NAVIGATION - INSTALLATION OF DUAL LITEF HYBRID NAVIGATOR UNITS AND RNP AR = 0.3 SOFTWARE

MODEL	SERIAL NUMBERS
680A (Citation Latitude)	-0001 thru -0247

SB680-34-17 Navigation - Installation of Dual LITEF Hybrid Navigator Units and RNP AR = 0.3 Software

Figure 1. Installation of the Dual Litef Hybrid Navigator Units and Configuration Modules (Sheet 1)

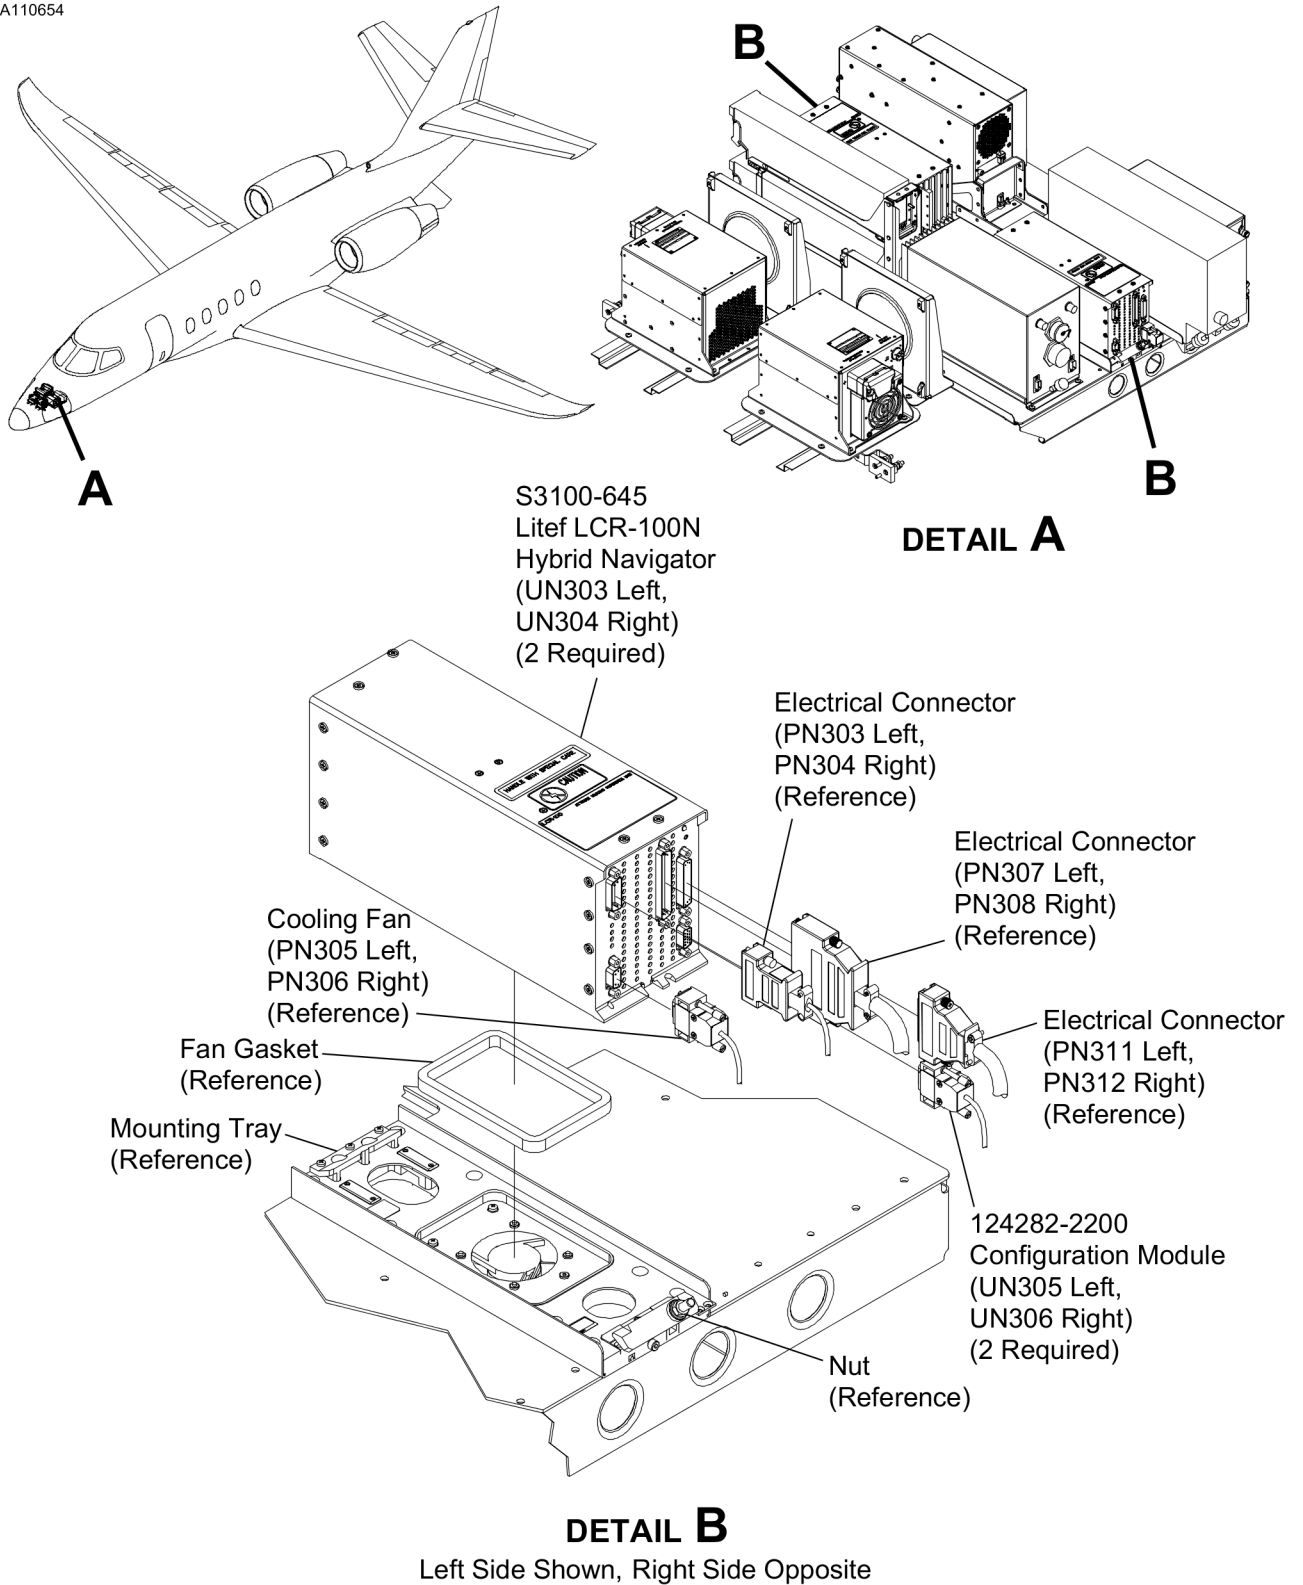
2. (Refer to Figure 1, Detail A.) Install the Upgraded Hybrid Navigators, do the steps that follow:
  - A. On aircraft with S3100-604 LCR-100N Hybrid Navigator Units installed, do the steps that follow:

- (1) Remove two S3100-604 LCR-100N Hybrid Navigator Units (UN303 left, UN304 right). (Refer to Cessna Model 680A Maintenance Manual, Chapter 34, Litef LCR-100N Hybrid Navigator-Removal/Installation.)

- (2) Go to Step 2.C.
  - B. On aircraft with S3100-612 LCR-100 Gyrocompass Units installed, do the steps that follow:
    - (1) Remove two S3100-612 LCR-100 Gyrocompass Units (UN303 left, UN304 right). (Refer to Cessna Model 680A Maintenance Manual, Chapter 34, Litef LCR-100N Hybrid Navigator-Removal/Installation.)

- C. Remove the two 124282-2100 Litef Configuration Modules (UN305 left, UN306 right). (Refer to Cessna Model 680A Maintenance Manual, Chapter 34, Litef Configuration Module - Removal/Installation.)

- D. Install two 124282-2200 Litef Configuration Modules (UN305 left, UN306 right). (Refer to Cessna Model 680A Maintenance Manual, Chapter 34, Litef Configuration Module - Removal/Installation.)

- E. Install two S3100-645 Litef LCR-100N Hybrid Navigator Units (UN303 left, UN304 right). (Refer to Cessna Model 680A Maintenance Manual, Chapter 34, Litef LCR-100N Hybrid Navigator-Removal/Installation.)
